# APPLICATION FOR BUILDING CONSENT

BC  
126108.

Provide a full description of the building work:  <i>E.g. 4-bedroom dwelling with multiple cladding types and attached garage</i>	Construct a new 4 bedroom single level dwelling with attached double garage. RCS insulated facade cladding & Linea cladding over cavity systems. Corrugated roofing systems. Tiled wet shower areas. Water tank storage and waste water systems
-----------------------------------------------------------------------------------------------------------------------------------------	-------------------------------------------------------------------------------------------------------------------------------------------------------------------------------------------------------------------------------------------------

Designed by	Version
Job No.	BC01 R1
Date:	Scale:
11 May 2017	1:1000, 1:250
12.05.27	Page
	A2 R1

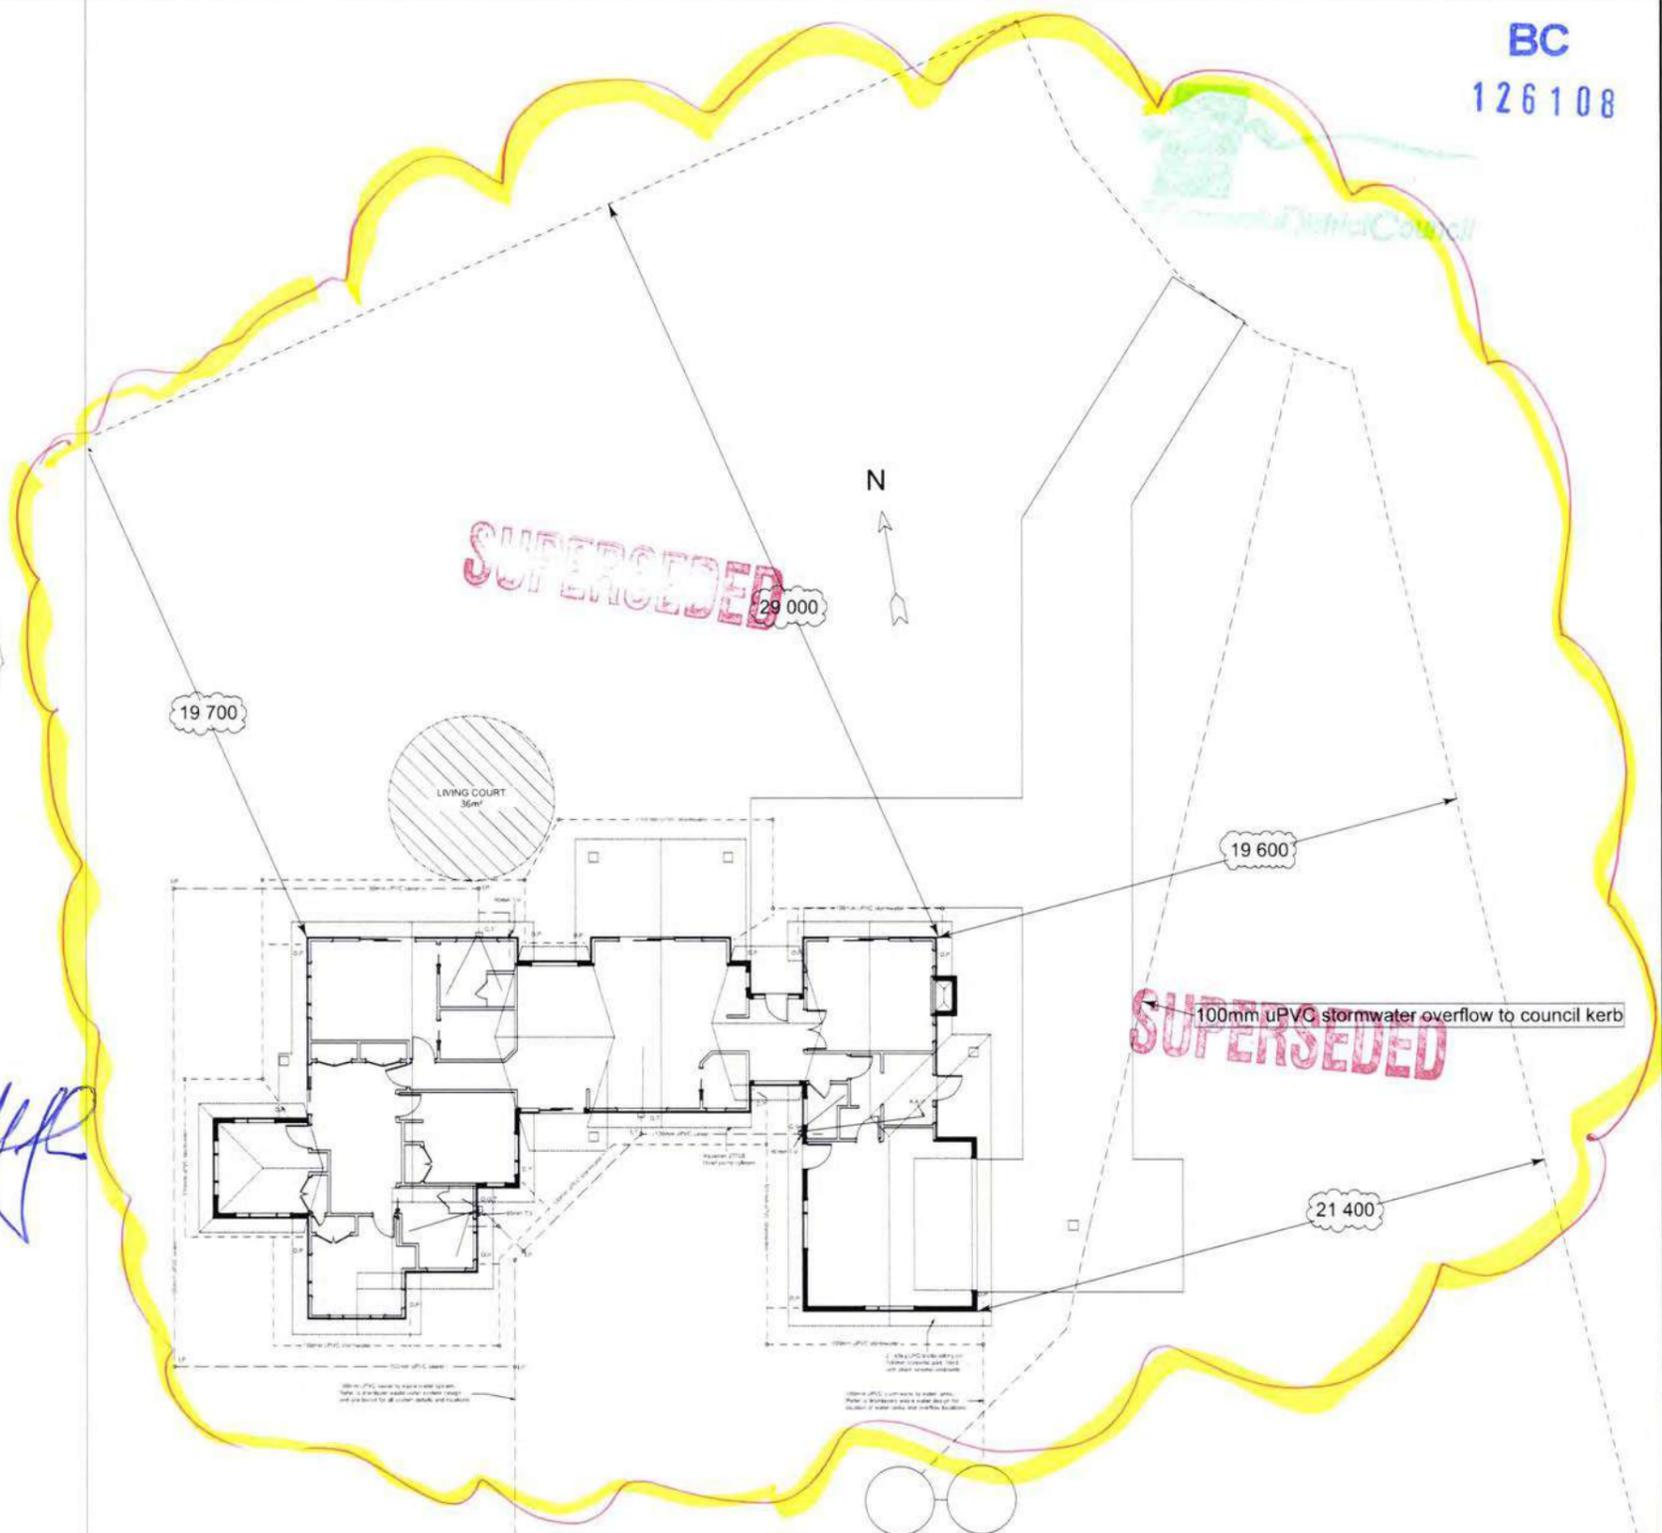
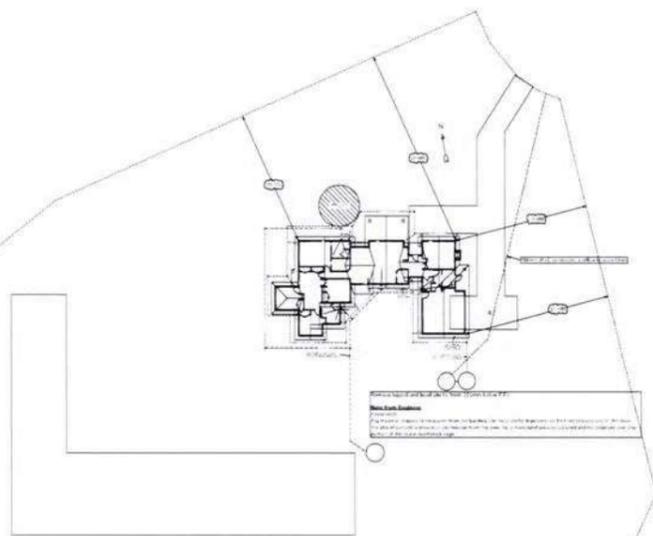
**Dwelling moved to 12.5 meters from Eastern boundary  
/ Complies with panning requirements  
Amended siting plan required**

Revision Table			
Number	Label	Date	Description
1	RFI	18/02/17	Stormwater Overflow
2	R1	11/05/17	Side boundary measurements

*Approved as minor variation*

<b>Designed by</b>	<b>Version</b>
	BC01 RFI
<b>Job No.</b>	<b>Scale:</b>
40649	1:1000, 1:250
<b>Date:</b>	<b>Page</b>
22 February 2017 09:18:37	<b>A2 RFI</b>

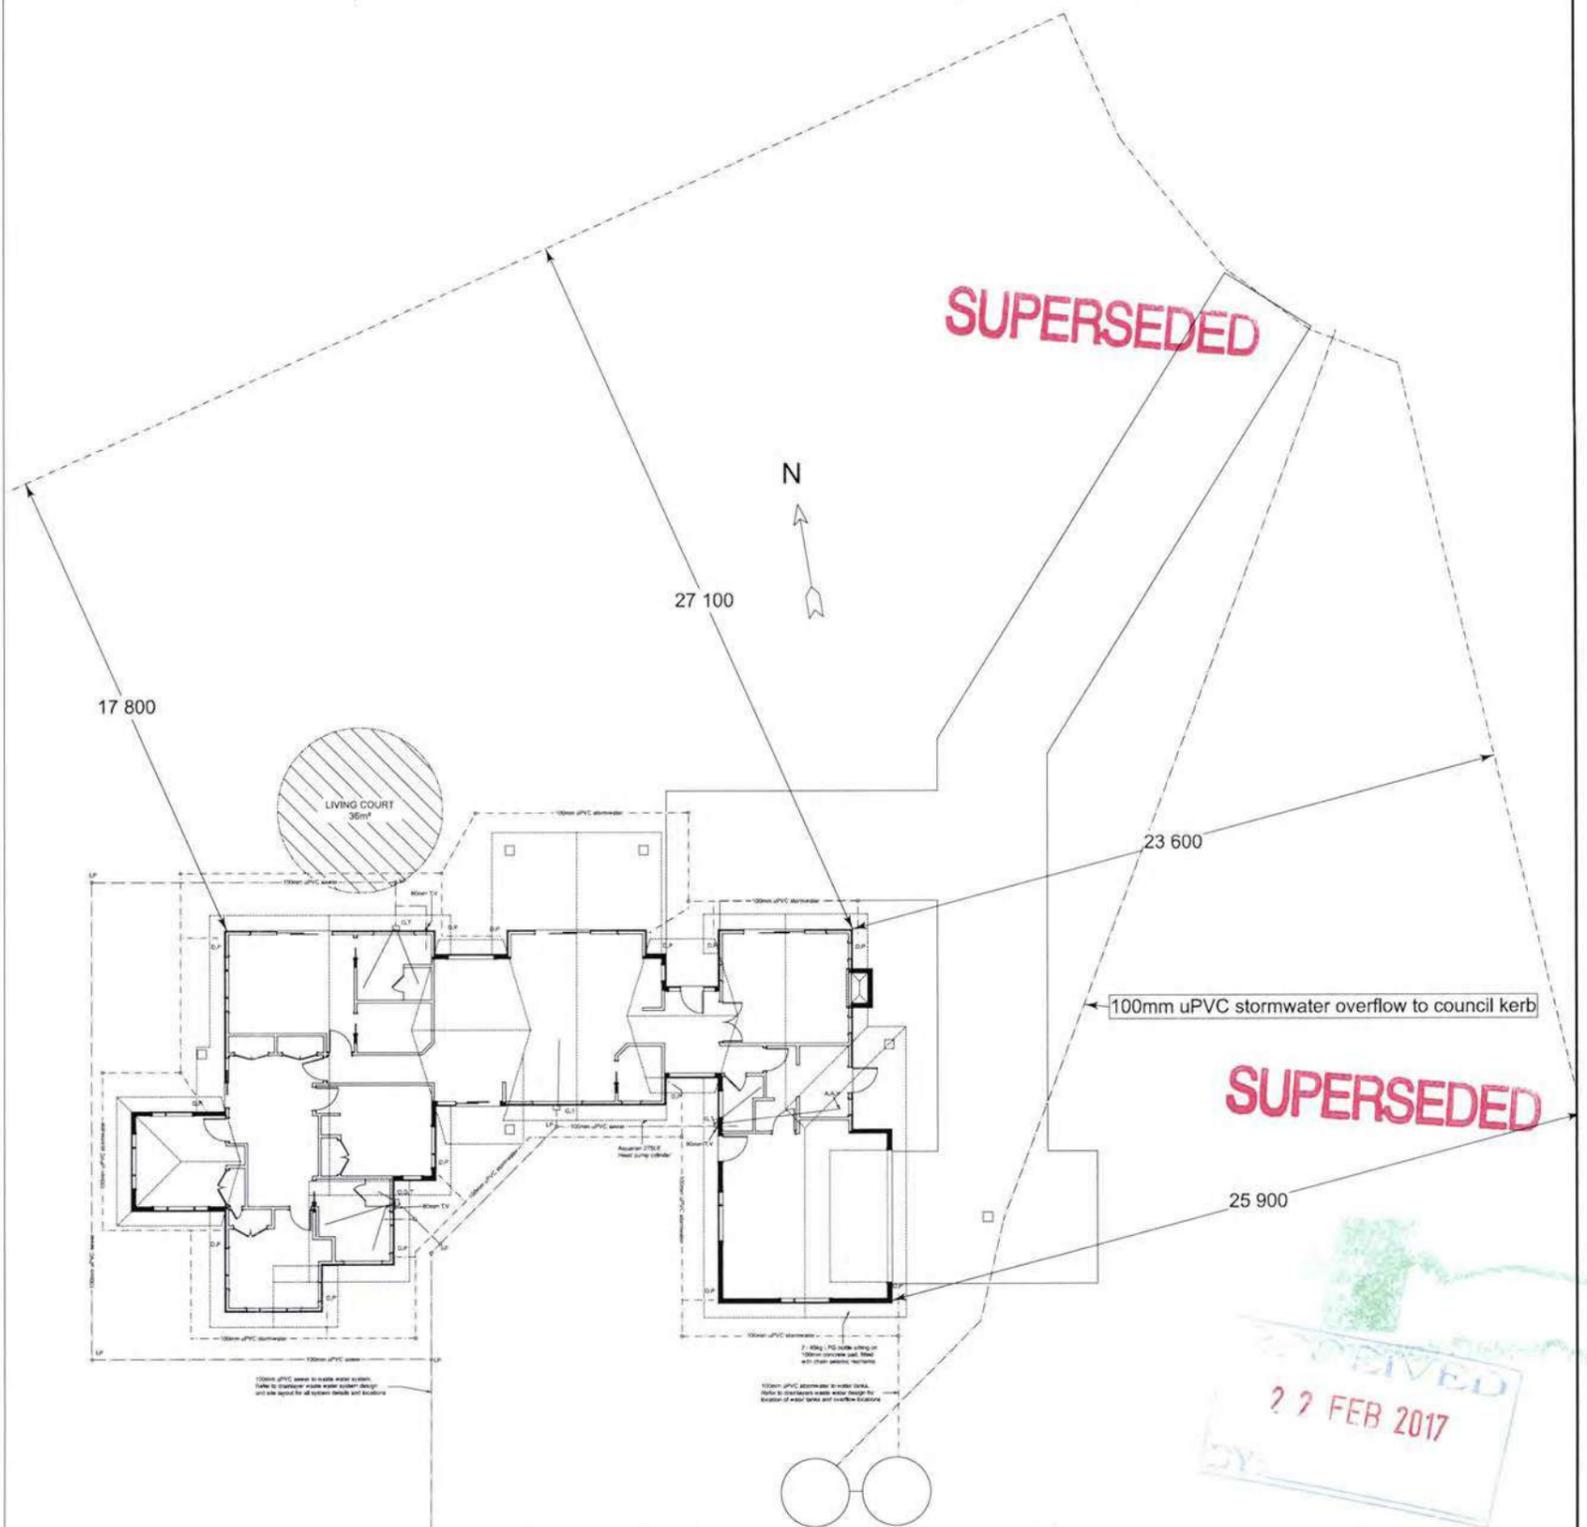
Revision Table			
Number	Label	Date	Description
1	RFI	18/02/17	Stormwater Overflow

**Designed by**  
 Version: BC01 RFI  
 Scale: 1:100  
 Page: A3 RFI

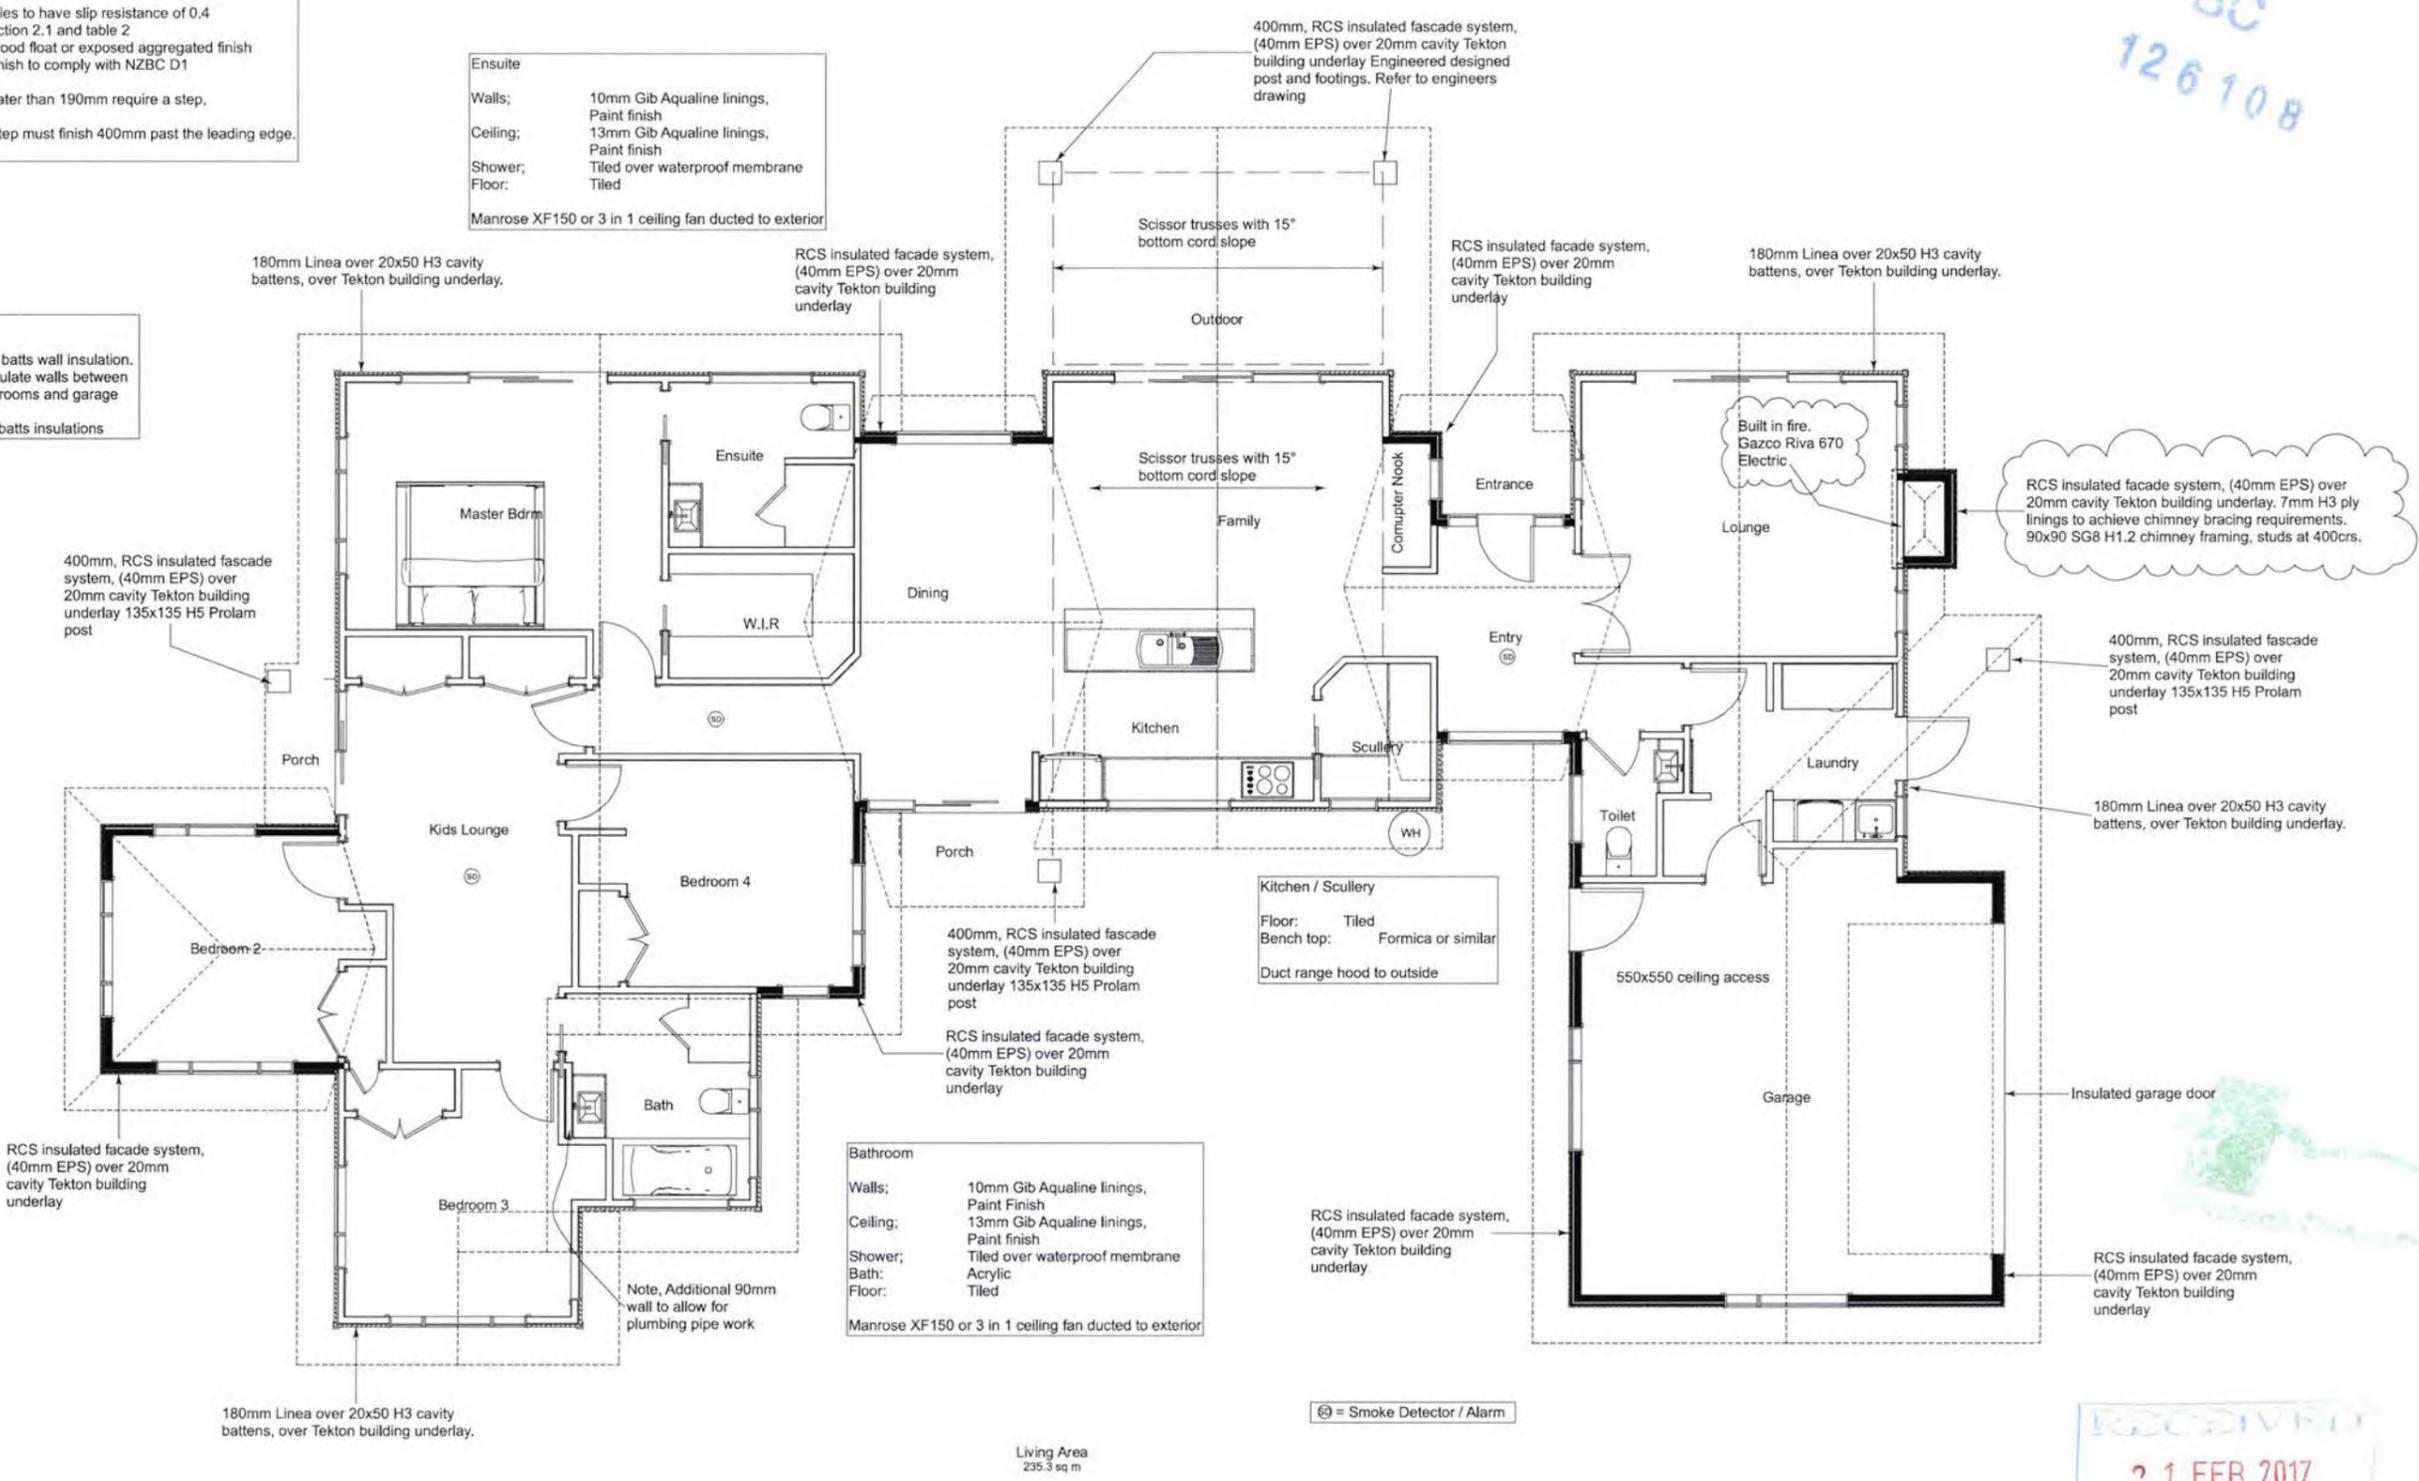
Revision Table			
Number	Label	Date	Description
1	RFI	18/02/17	Chimney Stud Centres
